No throttle actuation in trucks with EDC and Scania retarder

Fig. 1 Before modification

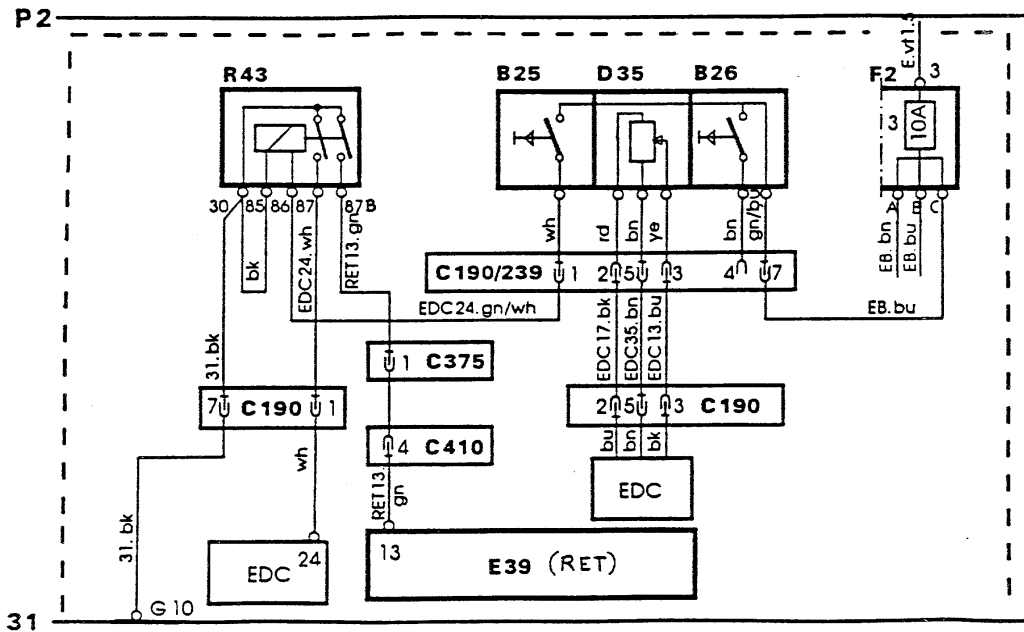
In order to alleviate this problem, relay R43 should be replaced with a diode unit, see work description. The throttle pedal sensor must also be changed. This solution is only for trucks with EDC and Scania retarder.

See the wiring diagrams in figs. 1 and 2 which show connection before and after modification.

5. Remove relay R43 (located on a separate relay holder in the central electric unit).
 6. Detach leads and terminals from the relay holder.
 7. Fit the diode unit in the relay holder.

8. Detach lead EB (Note: located on pin C) from fuse 3 in fuse holder F2.
- Note:** There is also a lead marked EB on pin B on the same fuse. Do not use this lead.

9. Connect lead EB (located on pin C) to lead 31.bk from the relay holder. Use joining sleeve part No. 1 112 499.
 10. The remaining leads detached from the relay holder should be fitted as follows:

- EDC 24.gn/wh to pin 5 on the diode unit.
 - EDC 24.wh to pin 8 on the diode unit.
 - RET 13.gn to pin 6 on the diode unit.
 11. Fit the relay holder and diode unit back in the same position.
